Docket No.: MP1483
(PATENT)

Patent No.: 7,428,260

For: UNIFIED MMSE EQUALIZATION AND
MULTI-USER DETECTION APPROACH FOR
USE IN A CDMA SYSTEM

**REQUEST FOR CERTIFICATE OF CORRECTION
PURSUANT TO 37 CFR 1.323**

Fig. 2

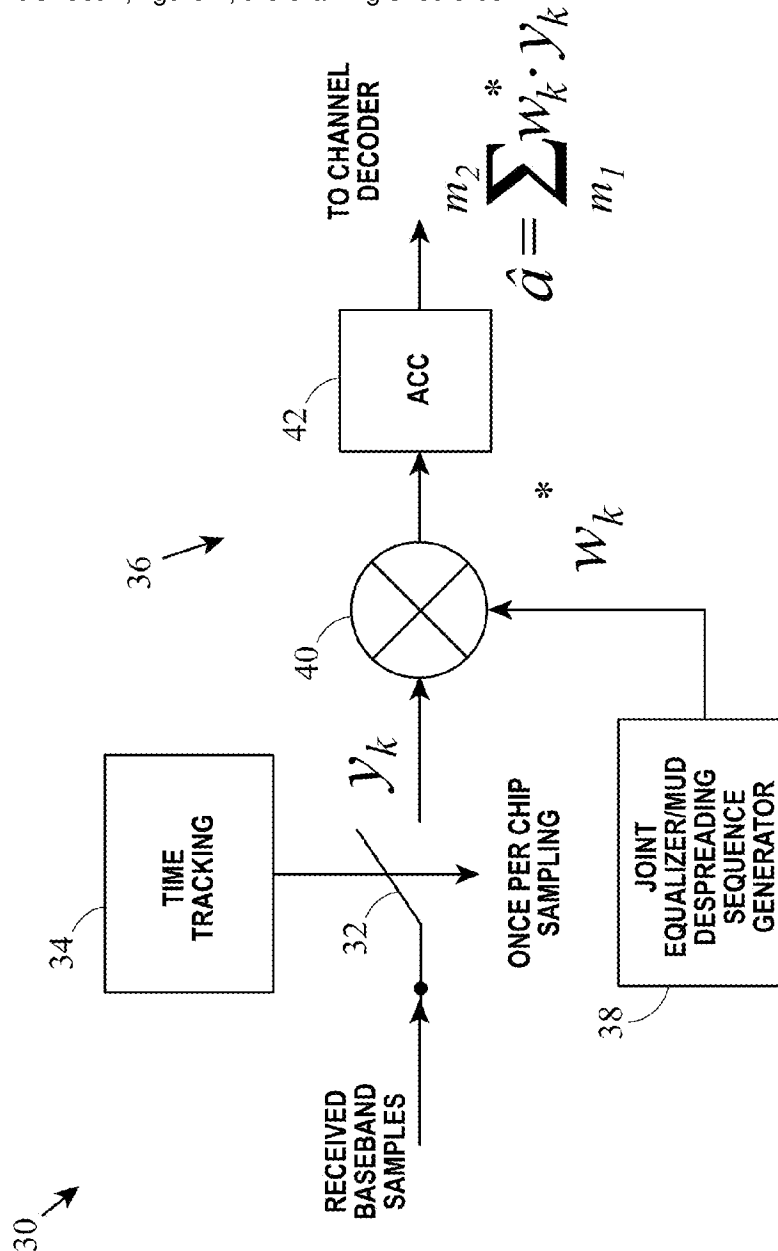
With regard to Sheet 2, Fig. 2 in the drawings, it appears that the Office published the annotated sheet instead of the replacement sheet submitted with the Amendment dated August 9, 2007.

At Sheet 2, figure 2, the drawing should be:
